ADDENDUM

AM 04

PROJECT : Forestside
PROJECT # : 1331.15
DATE : August 24, 2020

Title: Updated drawings

01. Oct.07.2019 Issued for tender
02. Mar.13.2020 Issued for design coordination #2
03. Mar.16.2020 Issued for addendum #2
04. Mar.16.2020 Issued for addendum #3
05. Aug.24.2020 Issued for addendum #4

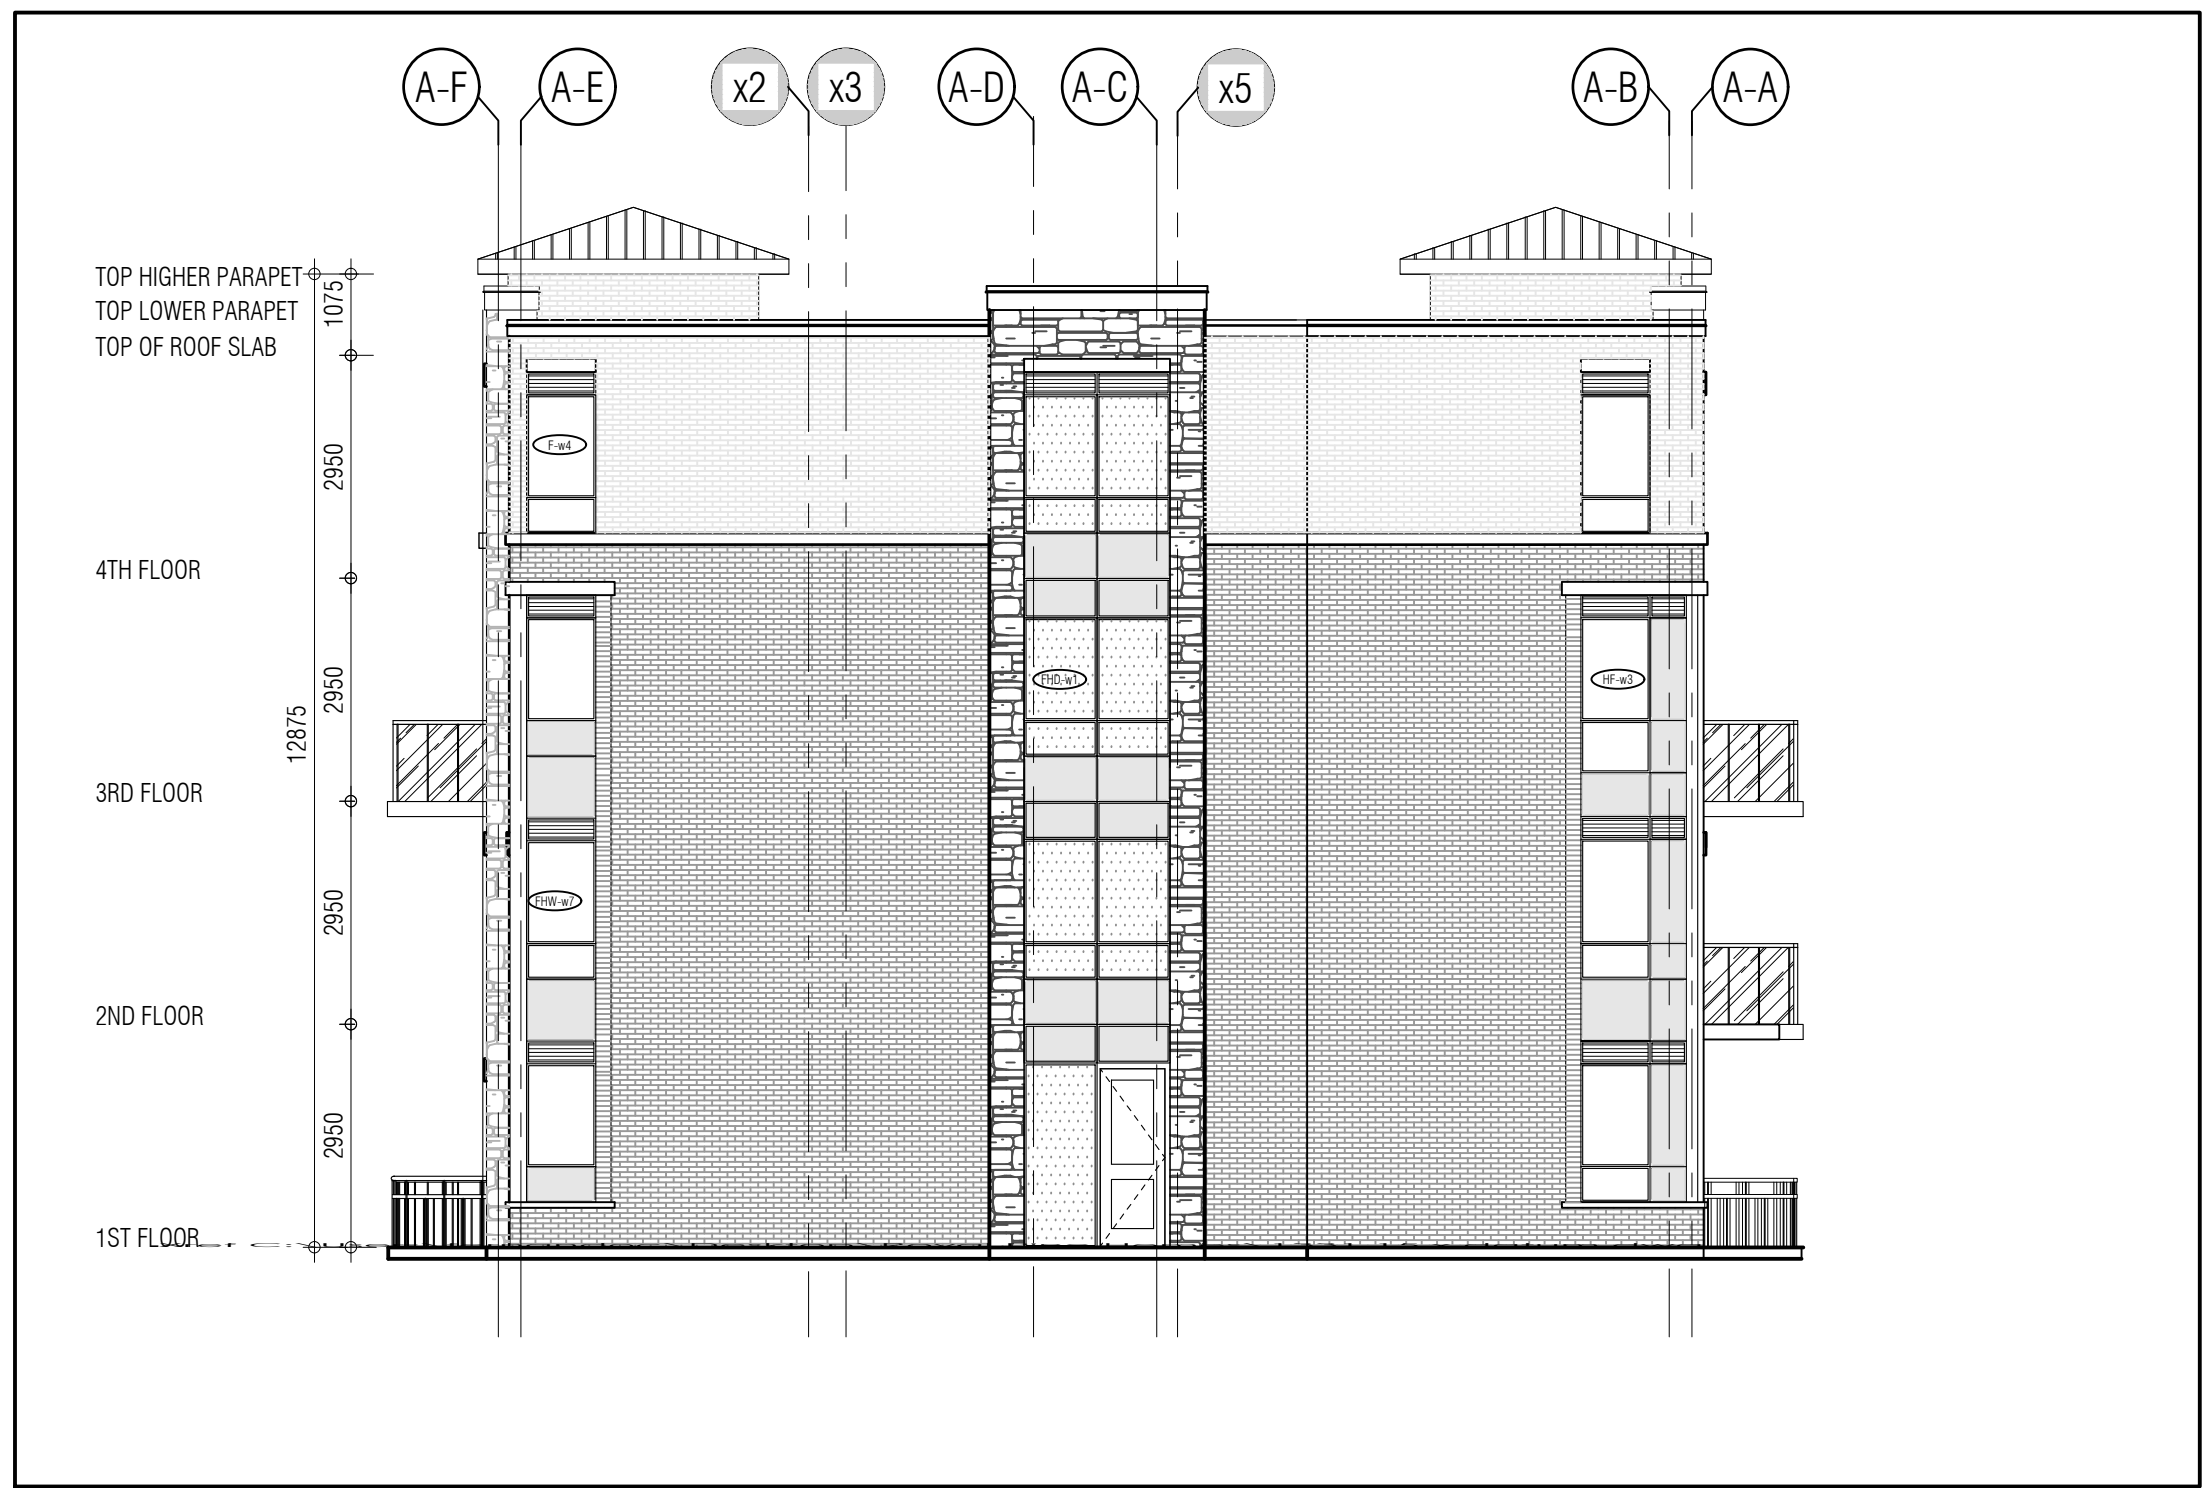
Reference:		Changes:
A-102	Wall Schedule	Revised Insulation and Sheathing on Exterior Brick, Stone, Concrete and Concrete Block walls to Spray Foam Insulation and Securock (CGC) Sheathing.
A-401 A-402 A-403 A-404	Building A Elevations Building B Elevations Building C Elevations Building D Elevations	Revised Key Plan Legend to match block elevation designation.
A-500	Building Sections	Revised all sections elevations to match updated exterior wall changes above.
A-600	Wall Sections	- Revised all wall sections to match updated exterior wall changes above. - Revised shelf angle location to be between suites on 3rd and 4th floor where it is one suite to act as Firestop and Added Firestop to floors in between suites at lower levels that do not require shelf angle.
A-900	Section Details	Revised all wall sections to match updated exterior wall changes above.
